SUMMARY OF CONCERNS IN RELATION TO THE PROPOSED NORTHCONNEX TUNNEL

This is an objection to many aspects of the proposed NorthConnex tunnel.

SECTION A: THE CONNECTIVITY OF NORTHCONNEX SOUTHERN VENTILATION FACILITY AT THE SOUTHERN INTERCHANGE, THE SOUTHBOUND TUNNEL IN PARTICULAR

MOTORWAY OPERATIONS COMPLEX - SOUTHERN VENTILATION FACILITY - SECTIONS
M1-M2-5000-DR-JD-0525

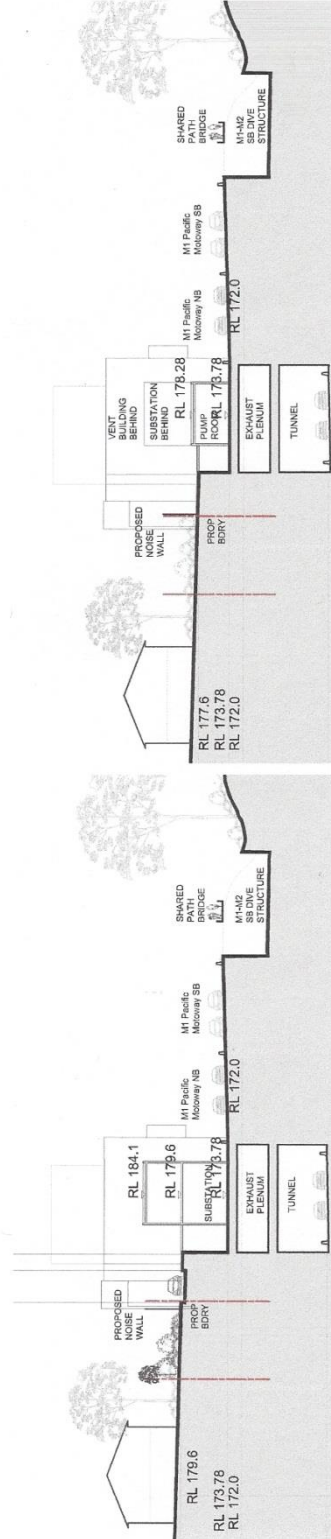
5. *EIS Volume 4, Technical working papers - Urban Design, 6.0 Operational Ancillary Facilities*
EIS Page 99 there is the diagram "Motorway Operations Complex – Southern Ventilation Facility – sections. *Page 10 below* The diagram has the cryptic label "Connection to tunnel TBC". What does TBC stand for? To be considered? Why is tunnel singular? Which tunnel is the diagram referring to northbound or southbound? There is no diagram showing any connection from the Southern Interchange ventilation facility to either the northbound or the southbound tunnel in any way AND YET

CONNECTION TO TUNNEL
TBC

- Diagrams need to be provided showing the inter-relation between the shaft, the ventilation outlet and the motorway operations centre with a clear description of what is to be constructed and how it will operate.
- The community needs irrefutable evidence that the polluted air from the southbound tunnel exit portals will not be allowed to flow like an invisible sewer through West Pennant Hills, North Rocks, Carlingford and Beecroft.

M1-M2-5000-DR-UD-0550
NORTHERN VENTILATION FACILITY - CROSS SECTIONS

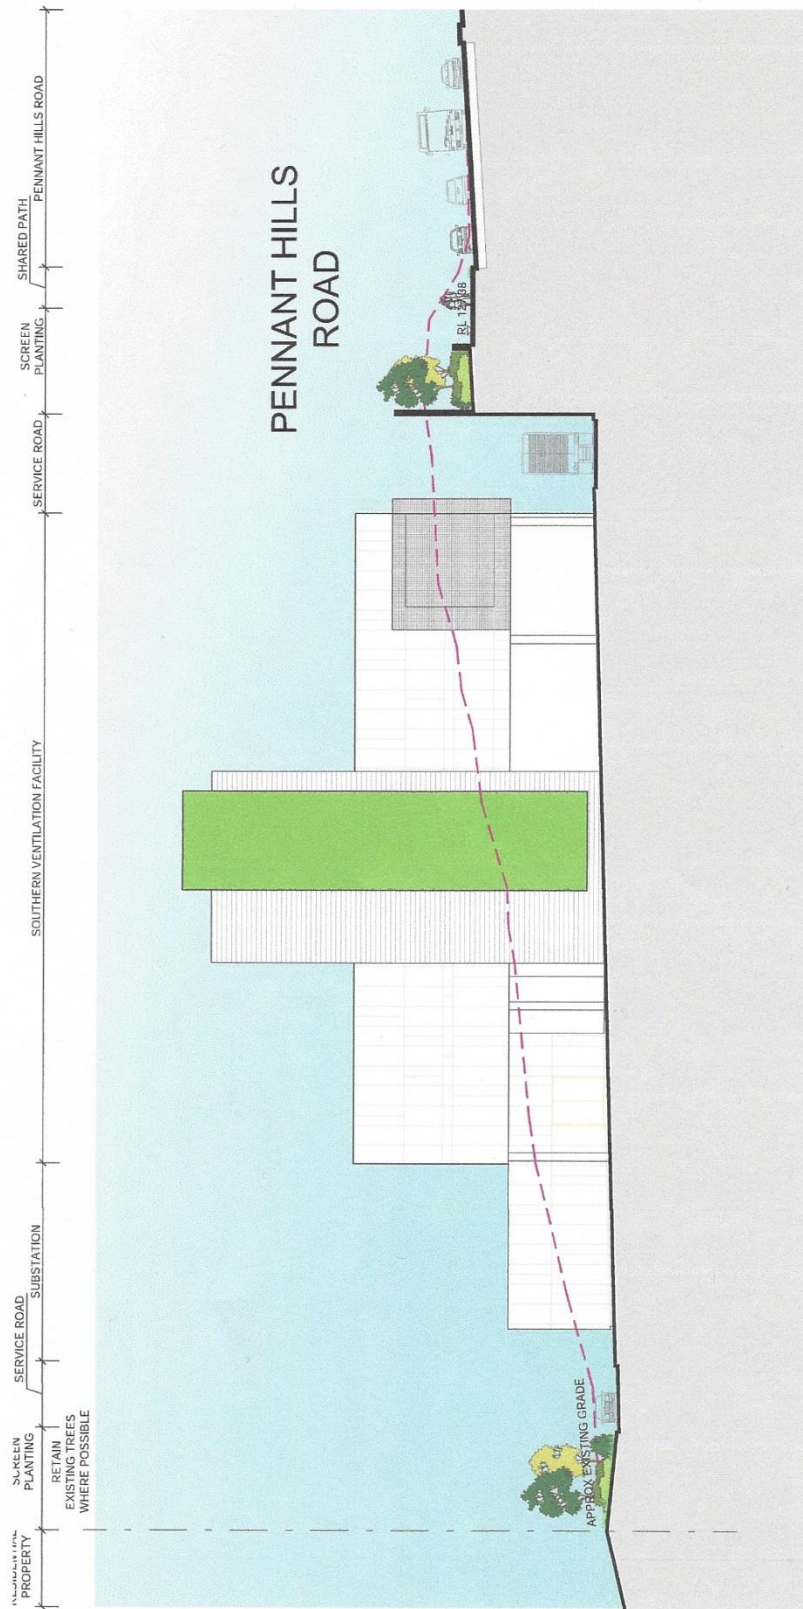
EIS page 135 *Page 11 below* there is a very explicit diagram showing the *Northern Ventilation Facility – cross section*.

M1-M2-5000-DR-UD-0556
NORTHERN VENTILATION FACILITY - LONG SECTION

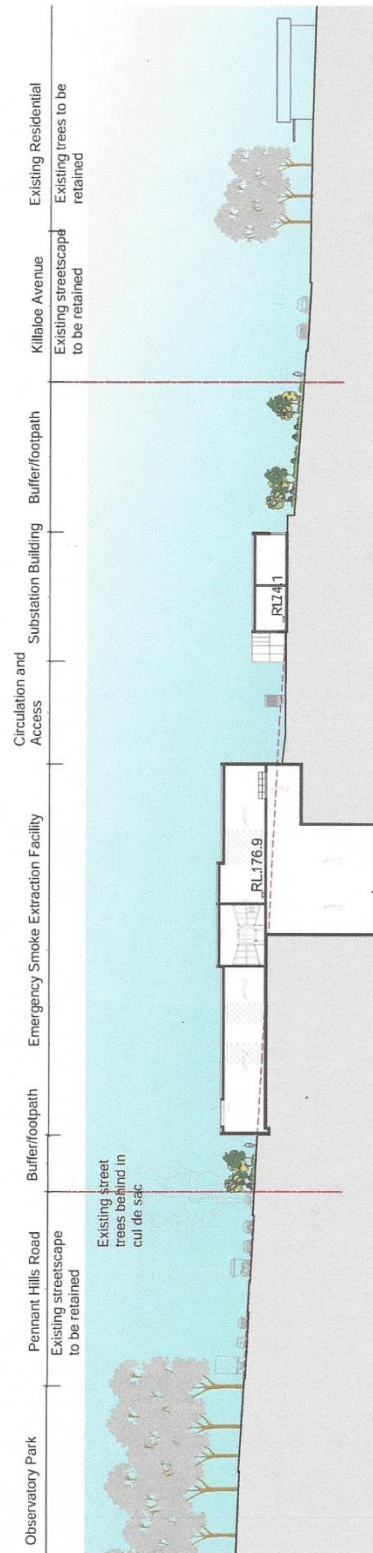
EIS page 134 *Page 12 below* there is a very explicit diagram showing the *Northern Ventilation Facility – long section*.
